# Switch Selection SIGNIFICANT

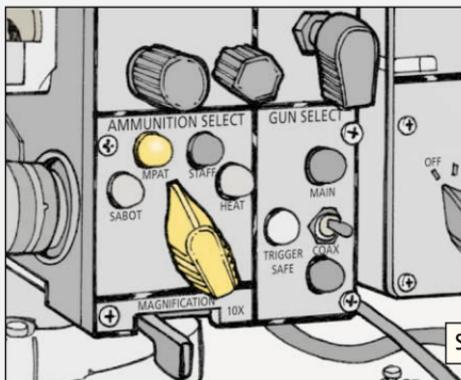
I WONDER  
WHAT'S THE  
*RIGHT* SETTING  
FOR MY M908  
ROUNDS?

**G**unners, selecting the right position on the GPS ammunition select switch isn't so clear-cut when it comes to using M908 high explosive obstacle reduction tracer rounds. The switch doesn't specifically pinpoint the right setting to use.

The correct setting is MPAT. Until the TMs can be updated, get out your stubby pencils and make the following change to the -10-1 TMs:

**(Note: When firing M908 ammunition, gunners must select MPAT on the ammunition select switch.)**

Add the note after Step C on Page 2-421 of TM 9-2350-264-10-1 (M1A1). The note goes after Step D on Page 2-598 of TM 9-2350-288-10-1 (M1A2) and Page 2-581 of TM 9-2350-388-10-1 (M1A2 SEP).

Select MPAT when firing M908 rounds
